Access Compliance Report

Public Rights-of-Way

Intersection ID: 17742	Main Street: S_WENDOVER_RD	Cross Street: PROVIDENCE_RD	Location: NW
ADA ID: A2A7DE18E160	Ramp Type: BlendTrans2	Initial Pass/Fail: Fail	Overall Compliance: No
		Severity Score: 17.5

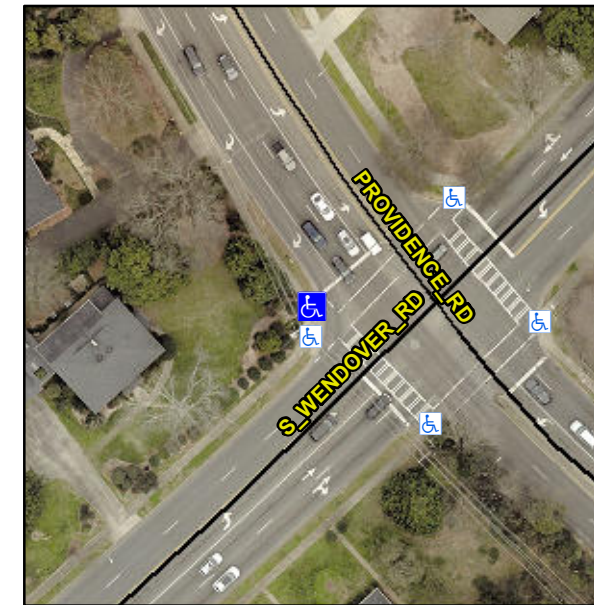
Not Found, R304.5.1

Compliance	Description	Data	Compliance	Description	Data
N/A	Ramp Length (in)	121.0	Yes	BlendTrans Slope (%)	3.3
No	Ramp Width (in)	33.5	Yes	BlendTrans XSlope (%)	0.4
N/A	Flare Type LT	N/A	N/A	Flare Type RT	N/A
N/A	Flare Slope LT (%)	N/A	N/A	Flare Slope RT (%)	N/A
N/A	Flare Traversable LT?	N/A	N/A	Flare Traversable RT?	N/A
N/A	Landing Length (in)	N/A	N/A	DWS Provided?	N/A
N/A	Landing Width (in)	N/A	N/A	DWS Contrast?	N/A
N/A	Landing Slope (%)	N/A	N/A	DWS Length (in)	N/A
N/A	Landing X Slope (%)	N/A	N/A	DWS Full Width?	N/A
N/A	Landing Curb? (Y/N)	N/A	N/A	DWS Offset (in)	N/A
N/A	Shared Landing?	N/A			
N/A	Gutter Ponding?	N/A	N/A	Gutter Slope (%)	N/A
N/A	Gutter Lip Ht (in)	1.0	N/A	Gutter X Slope (%)	N/A
N/A	Painted X Walk1?	Yes	N/A	Painted X Walk2?	N/A
	X Walk 1 Direction	To SE		X Walk 2 Direction	N/A
	X Walk 1 Width (in)	104.0		X Walk 2 Width (in)	N/A
	X Walk 1 Slope (%)	4.6		X Walk 2 Slope (%)	N/A
	X Walk 1 X Slope (%)	3.9		X Walk 2 X Slope (%)	N/A

N/A	Ramp inside XWalk1?	No	N/A	Ramp inside XWalk2?	N/A
	Road Slope (%)	3.9		Clear Space?	N/A
	Road X Slope (%)	4.6	N/A	Clear Space to XWalk (in)	N/A
N/A	Any Obstructions?	N/A	N/A	Storm Grate/Utility Hazard?	N/A
	Obstruction Type			Storm Grate/Utility Type	
		N/A			N/A
			Yes	Surface Condition? (G/P)	Good
			No	Curb Slope (%)	6.4

Remove & Replace Curb Ramp With Two New Directional Ramps or Equivalent. Restripe Crosswalk.
